# RETREAT AT TIMBERRIDGE FILING NO. 1

# CONSTRUCTION DRAWINGS

APRIL 2019

**CONCRETE CUT-OFF WALL (DETAIL 1) - SECTION A-A**  
SCALE: 1" = 2'

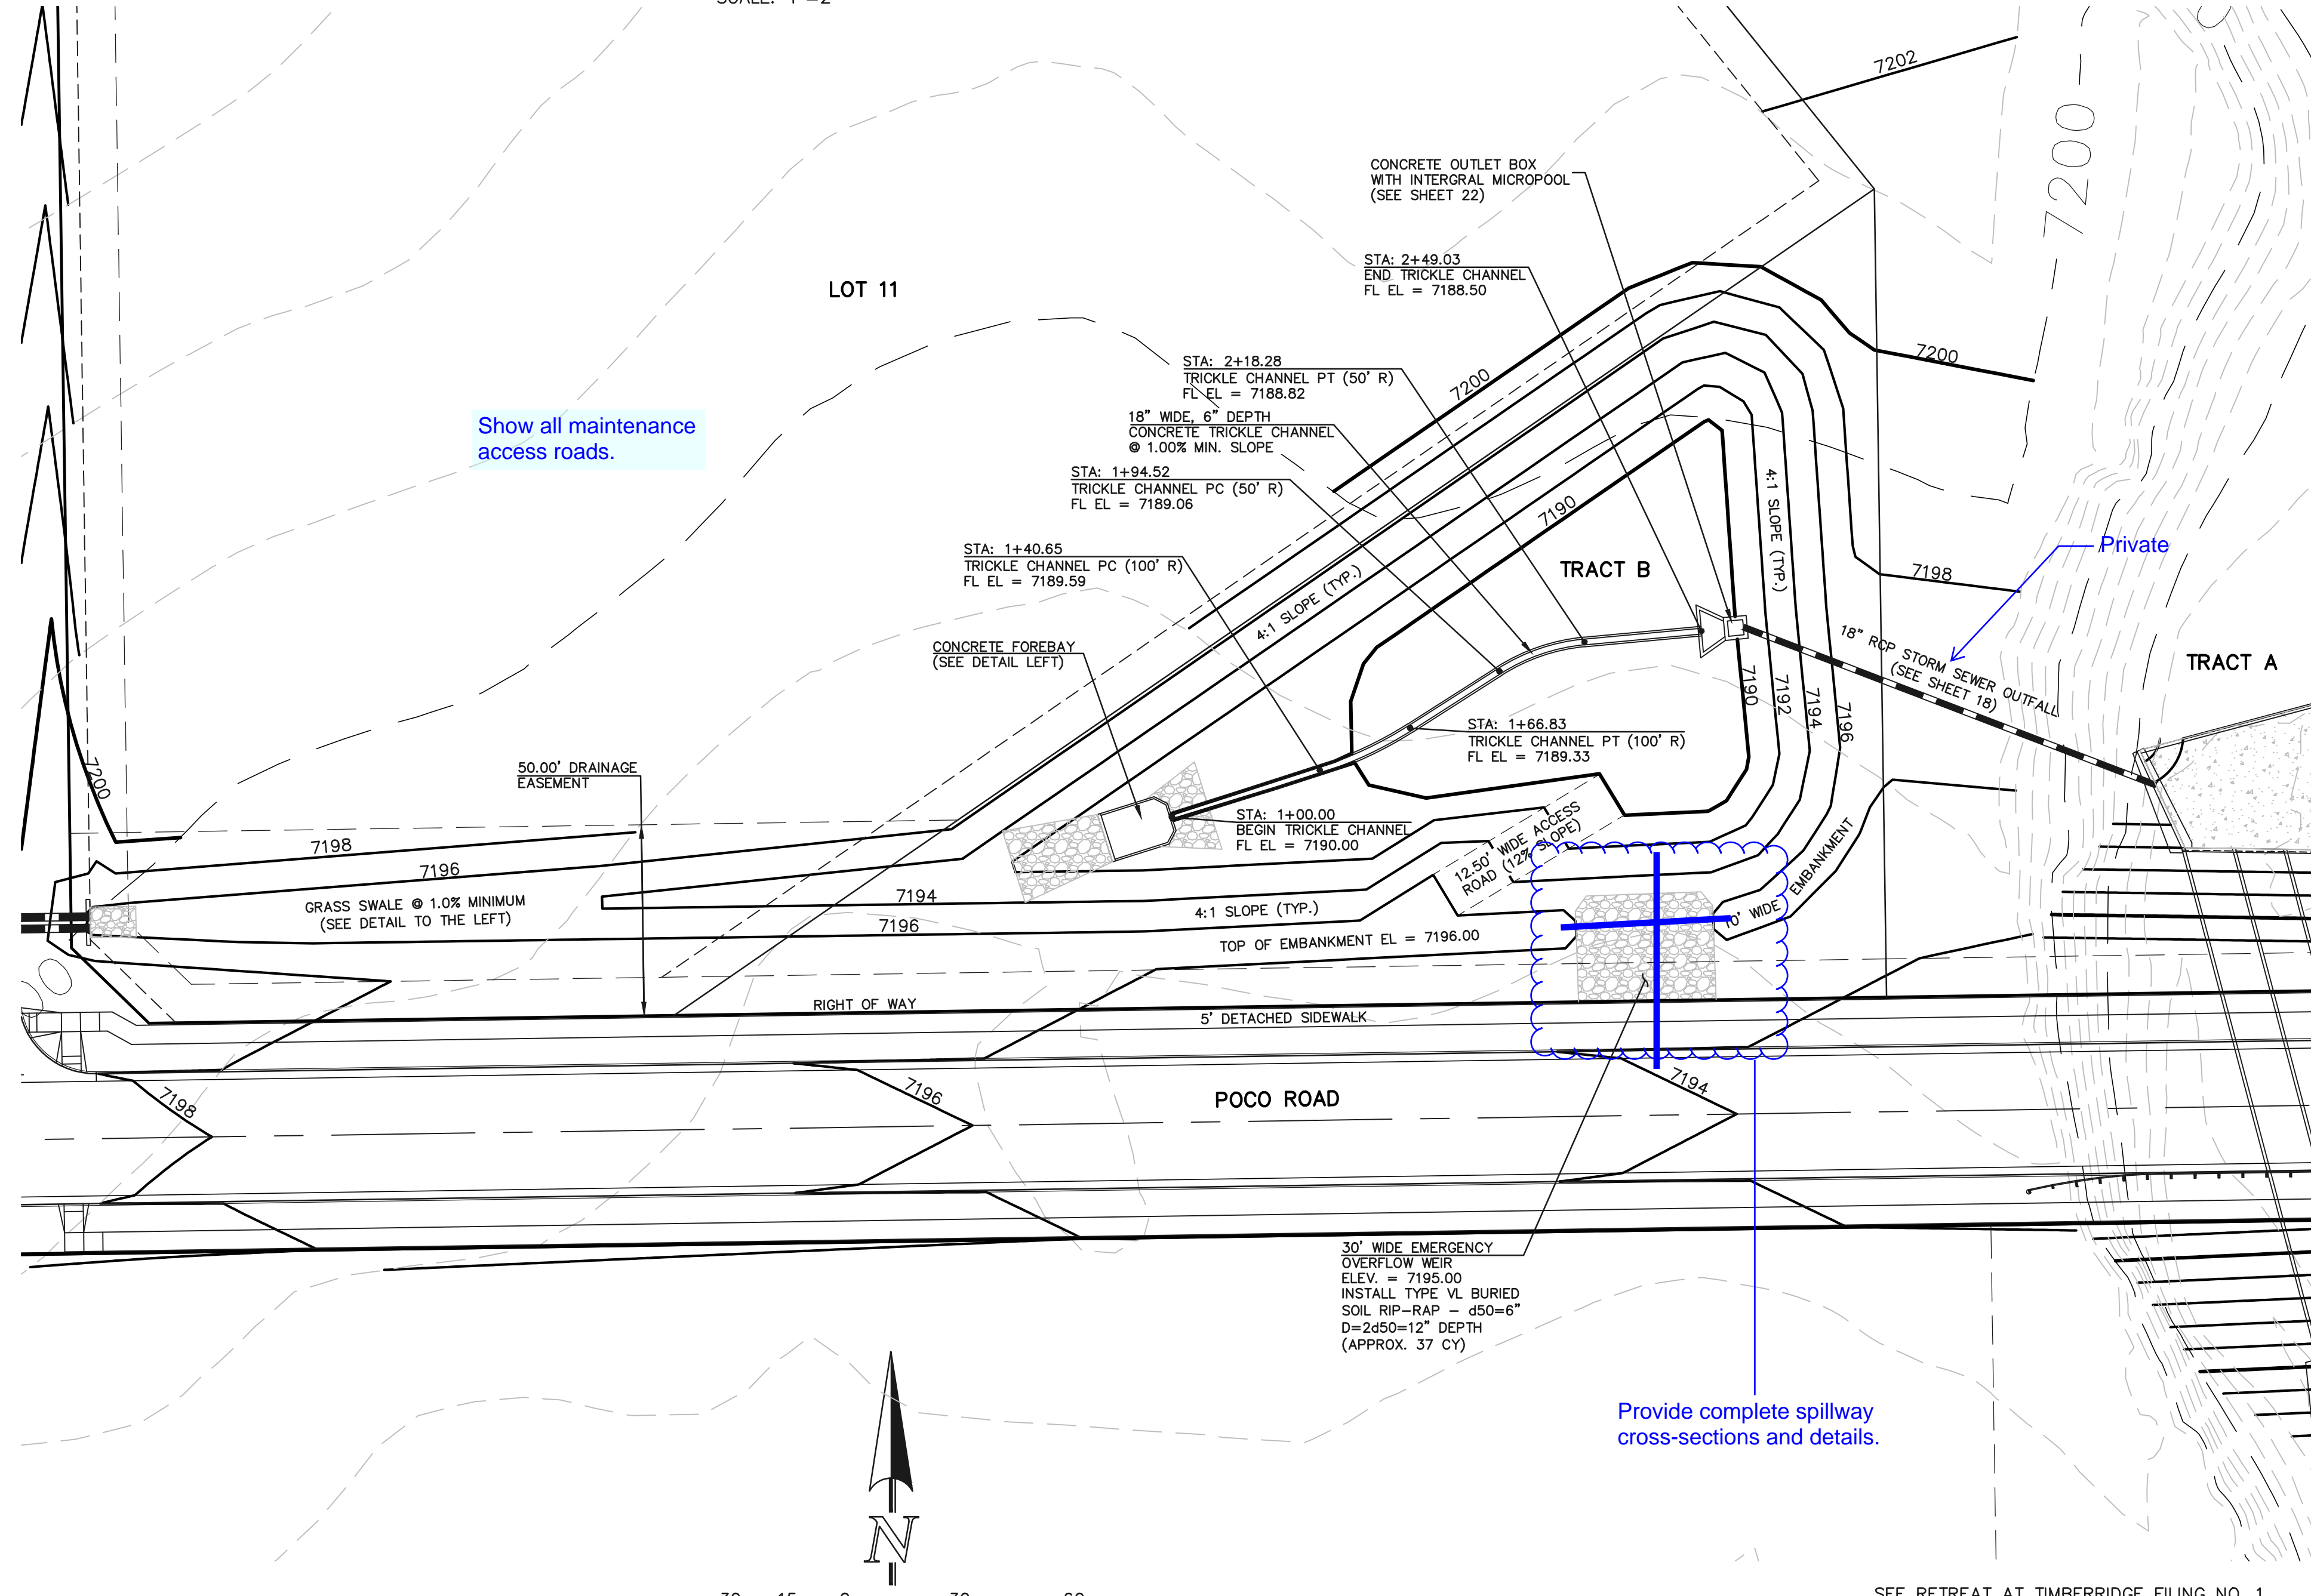
Show all maintenance access roads.

Provide complete spillway cross-sections and details.

**EASTERLY CONCRETE FOREBAY**  
SCALE: 1" = 5'

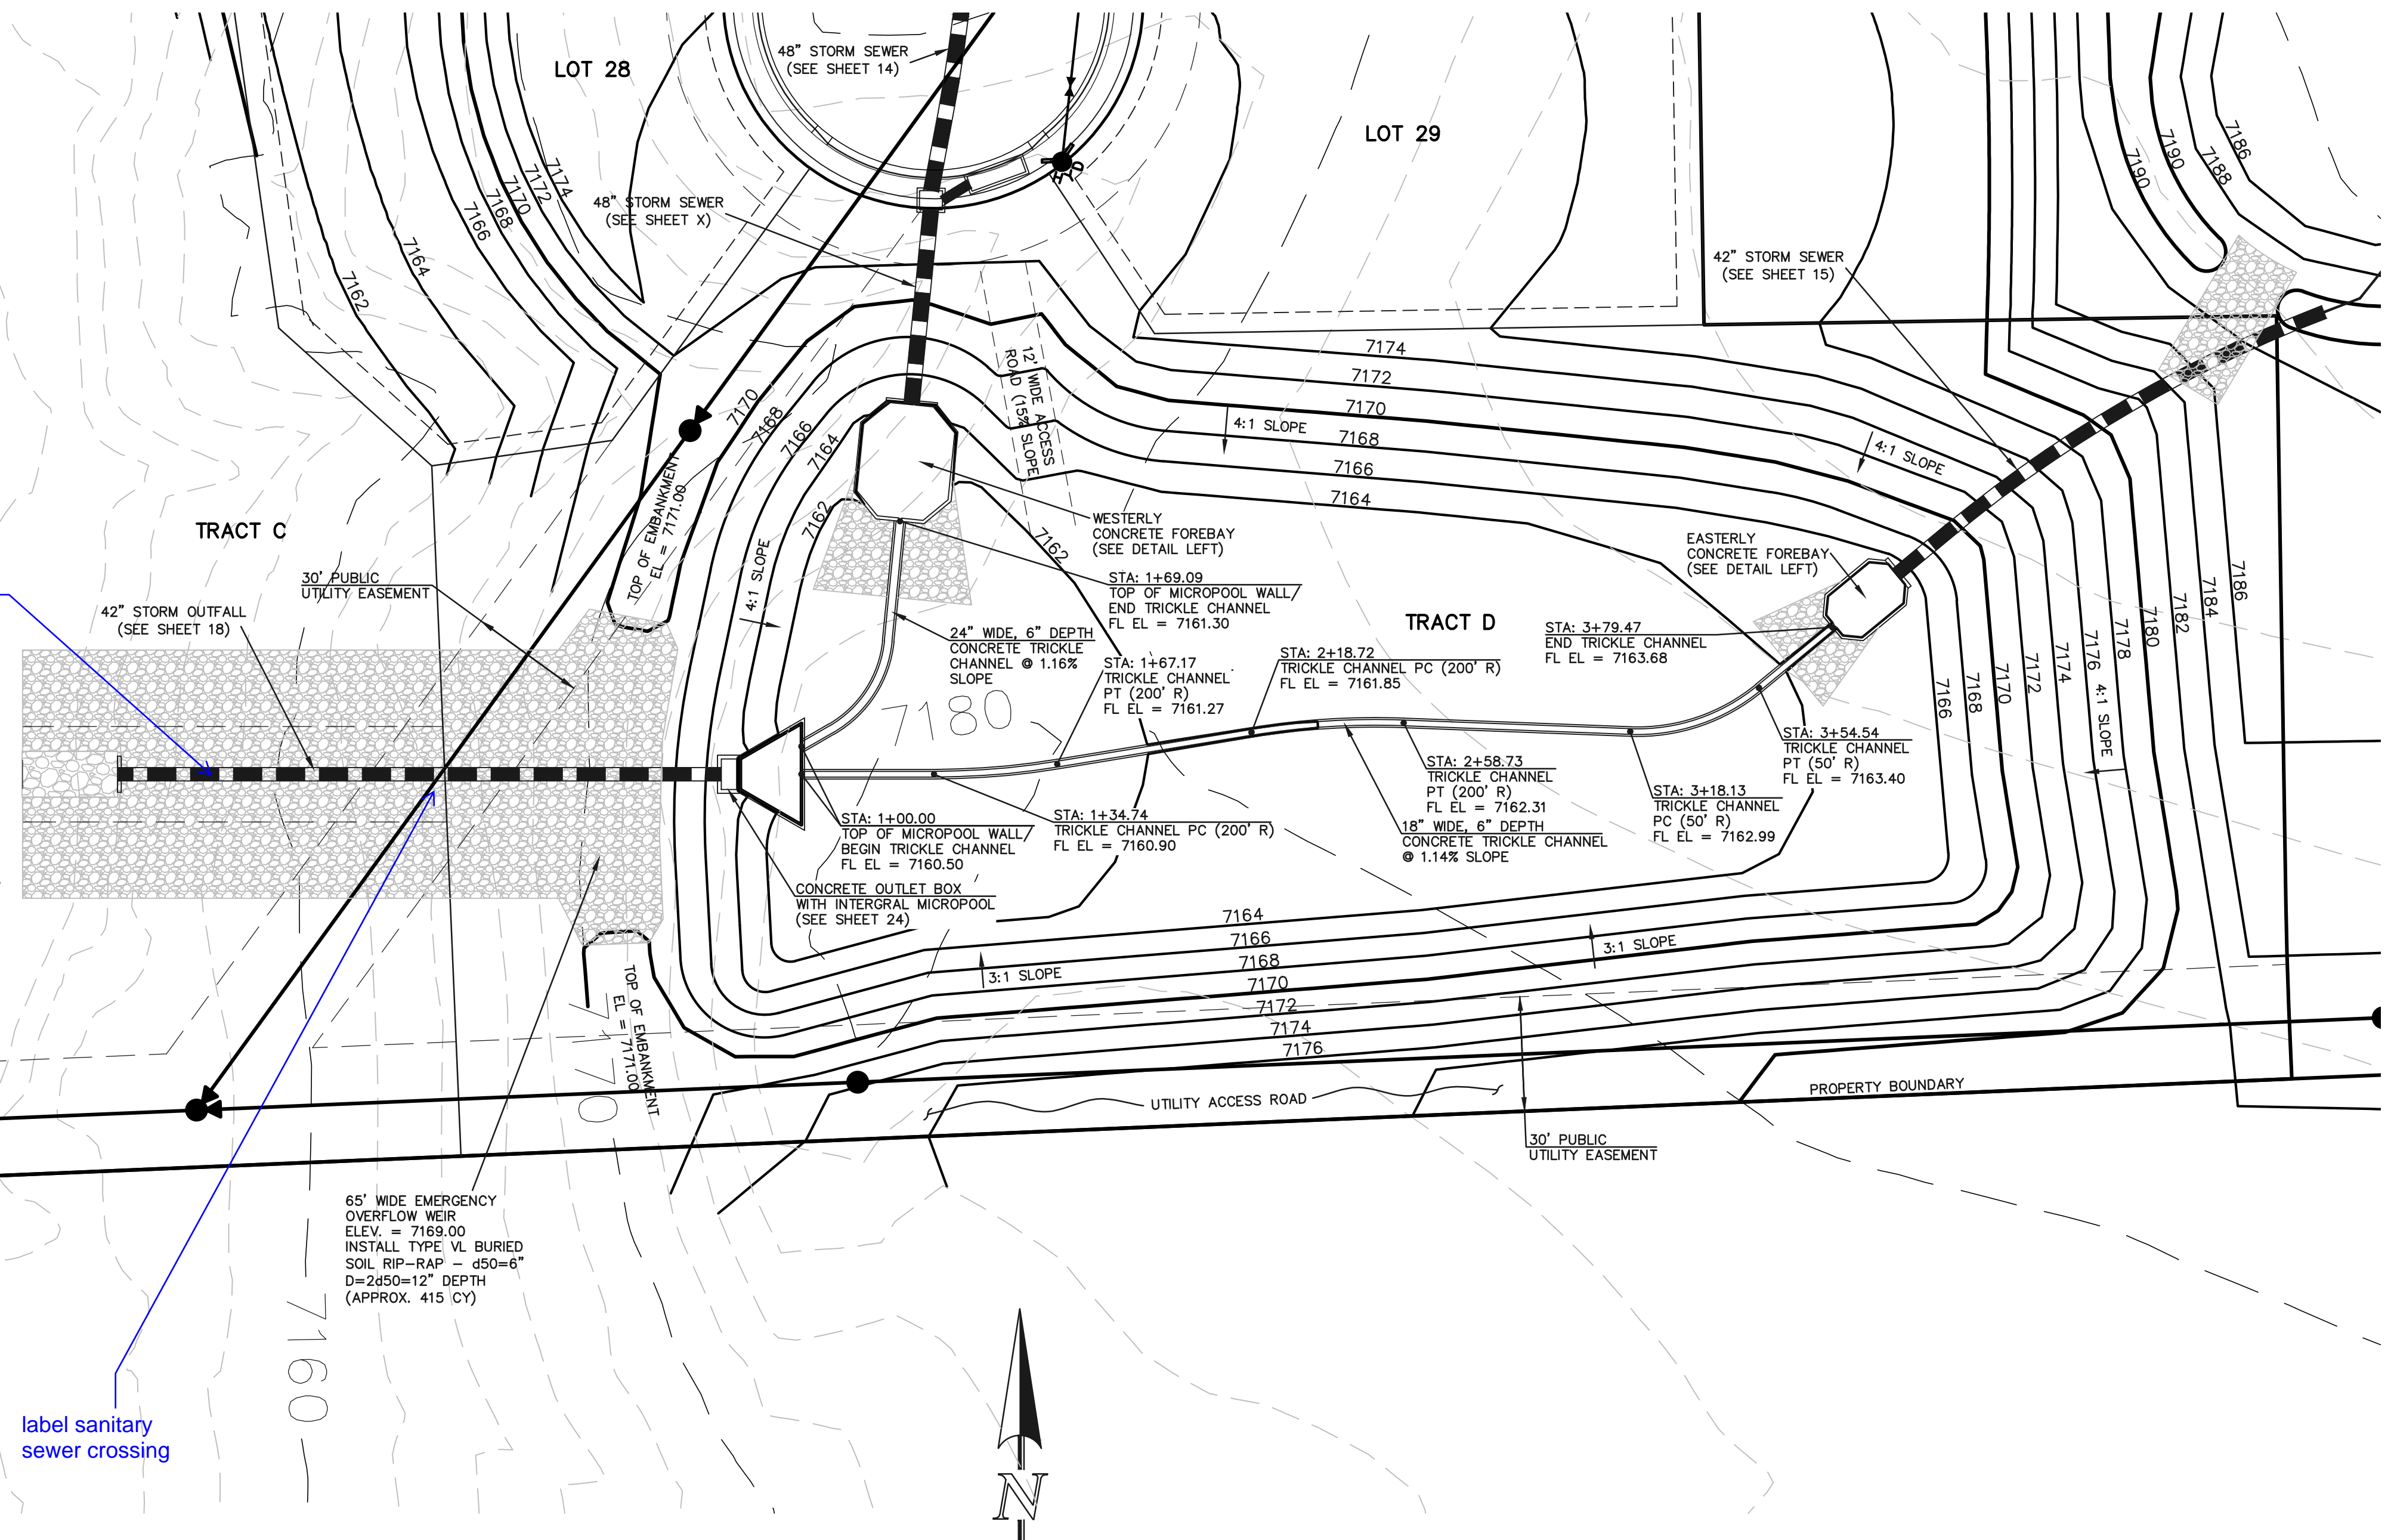
riprap will be on top of pipe. detail recommended.

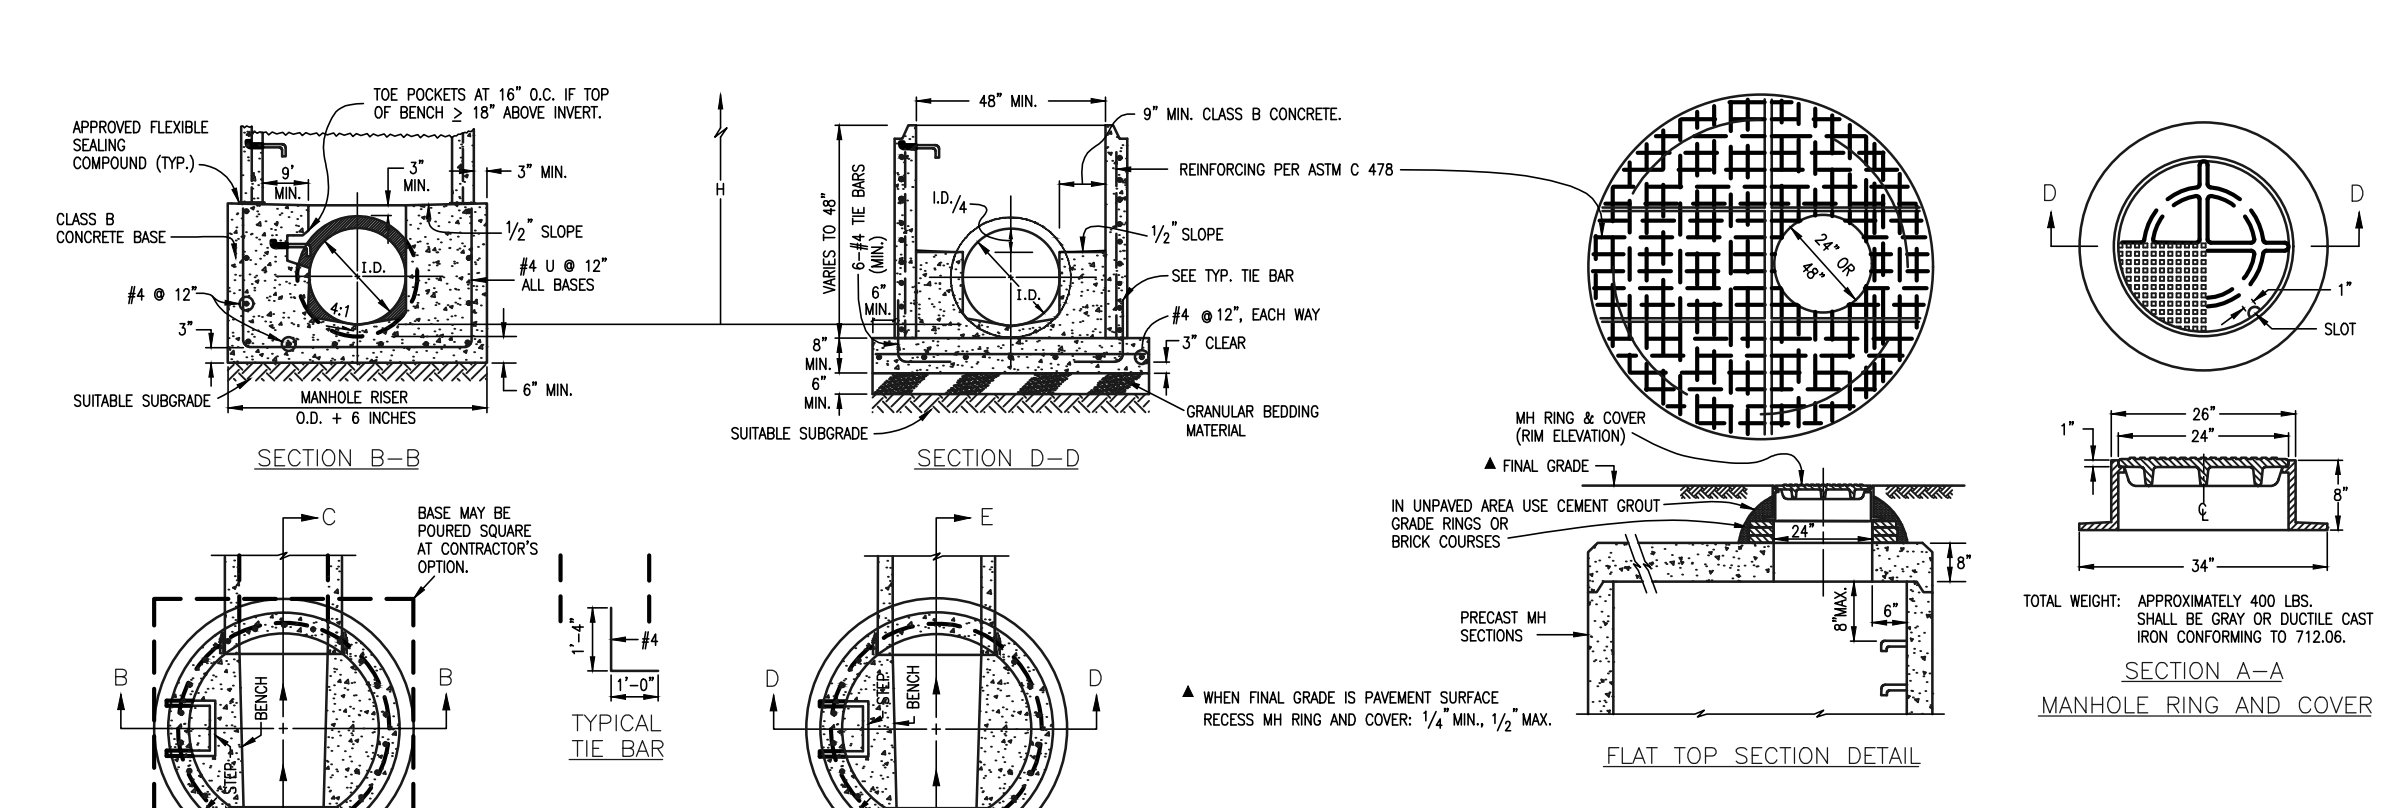
provide details for transitions from curb and gutter to zero-height, ditch
